RENESAS TECHNICAL UPDATE

Product Category	MPU&MCU	Document No.	TN-H8*-A311A/E	Rev.	1.00
Title	Usage Notes on SSU for H8SX/1520 Group and H8SX/1582	Information Category	Technical Notification		
Applicable Product	H8SX/1520 Group H8SX/1582	Lot No.	Reference Document	H8SX/1520 Group Hardware Manual (REJ09B0104-0200 Rev.2.00) H8SX/1582 Hardware Manual (REJ09B0199-0100Z Rev.1.00)	
		All lots

Figure 14.9, Figure 14.17 Example of Simultaneous Transmission/Reception Flowchart

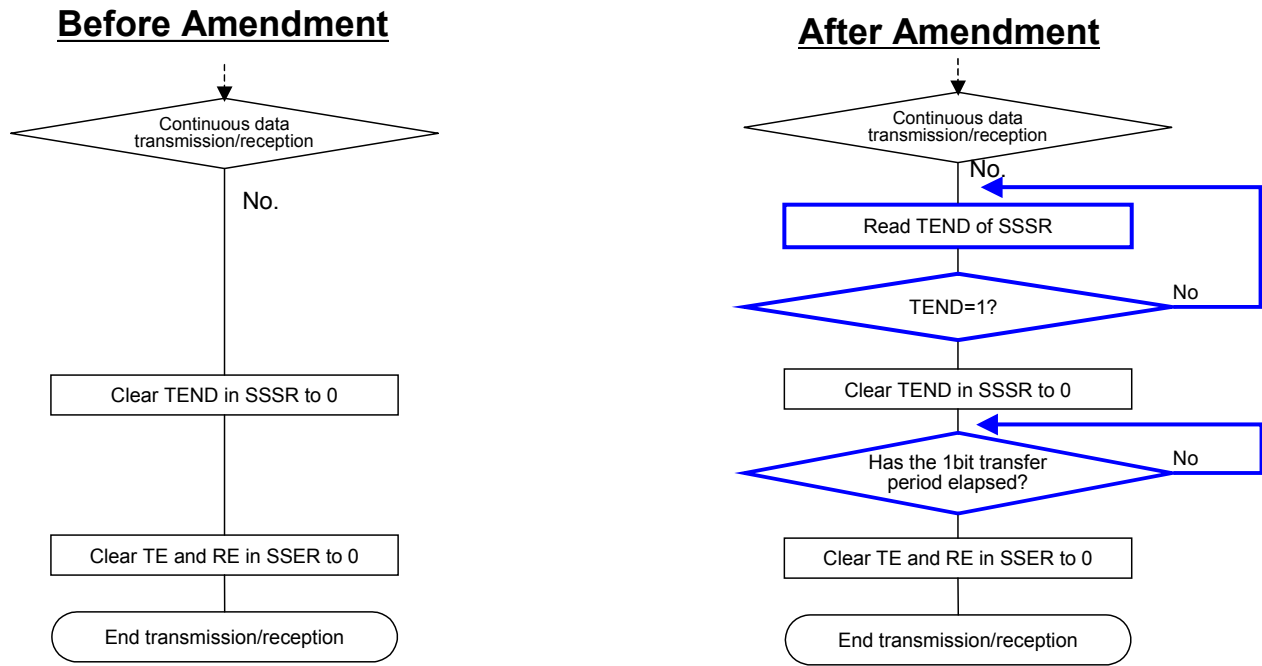
If a switch from transmission/reception operation to reception operation is made during transmission/reception operation, the first reception might not operate properly. Therefore, the confirmation of the transmission completion (TEND=1 judgment) and the confirmation of the processing the final 1bit will be added. Please confirm the following flow chart for details.

Please setting according to the following procedures when switching from transmission or transmission/reception operation to reception operation.

- ① Wait until Transmission END (TEND) of SS status register (SSSR) are set(TEND=1, transmission completion)
- ② TEND is set to '0' after confirming transmission completion (TEND=1).
- ③ Wait until the final 1bit is processed, and then TE and RE of SS Enable Register (SSER) are set to '0'.

Figure 14.4 Example of Initial Settings in SSU Mode.

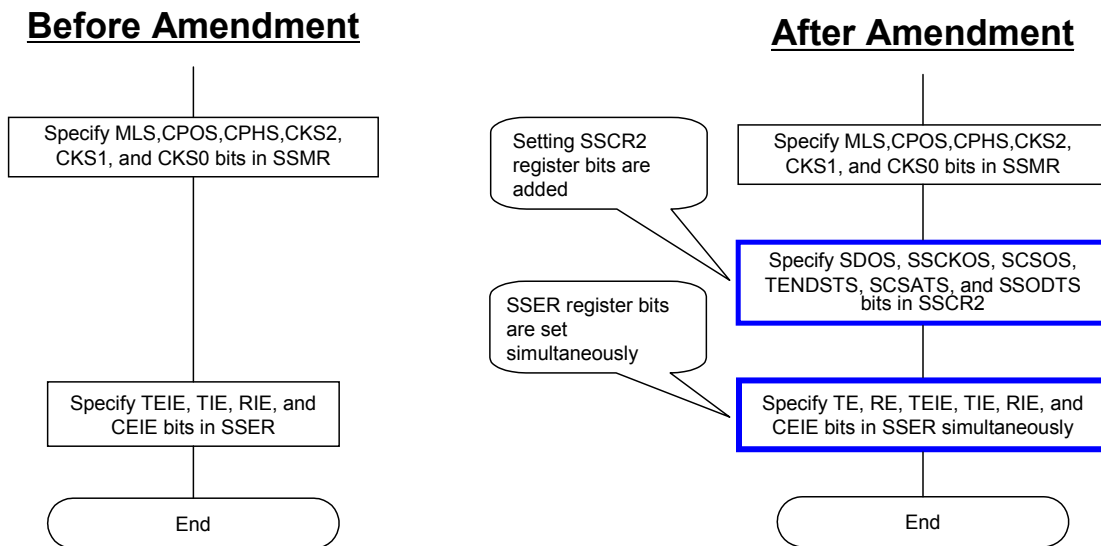
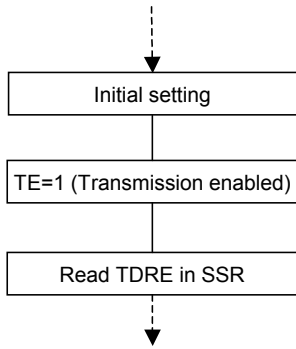
In the H/W manual, when TXI interrupt is used for transmission or simultaneous transmission/reception, TIE bit and TE bit are set separately,

In this setting, TIE bit of SSER register is set to "1" before setting TE bit of SSER register to "1" (transmission enabled), while the initial value of TDRE bit is "1". This holds for the TXI interrupt condition (TIE=1 & TDRE=1).

Setting TE bit and TIE bit simultaneously can avoid this. Therefore the initial setting flow and flowchart will be changed.

Also SSCR2 will be set in the initial setting. SSCR2 setting is added to initial setting flowchart.

Figure 14.6, Figure 14.14 Flowchart Example of Data Transmission

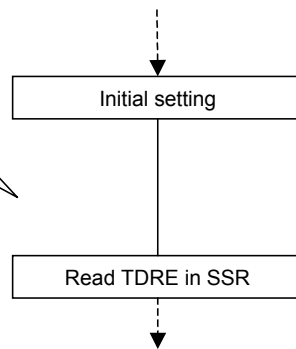
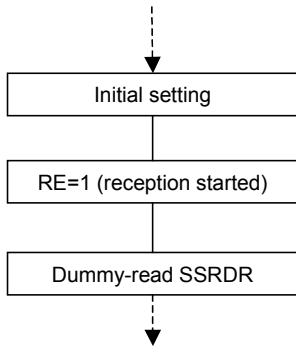
Removed TE bit setting because initial setting includes it

Figure 14.8, Figure 14.16 Flowchart Example of Data Reception

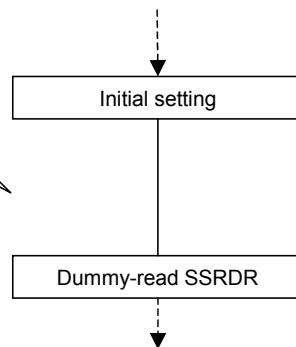
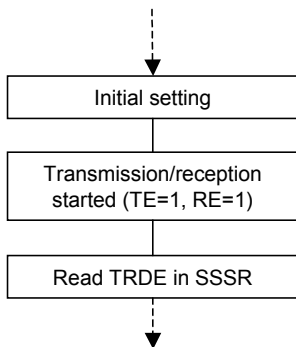
Removed RE bit setting because initial setting includes it

Figure14.9, Figure14.17 Flowchart Example of Data Transmission/Reception

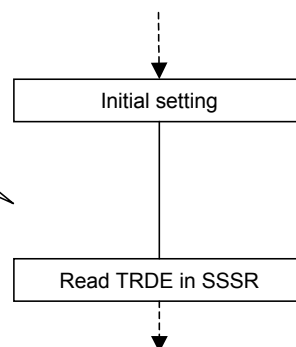
Removed TE/RE bit setting because initial setting includes it
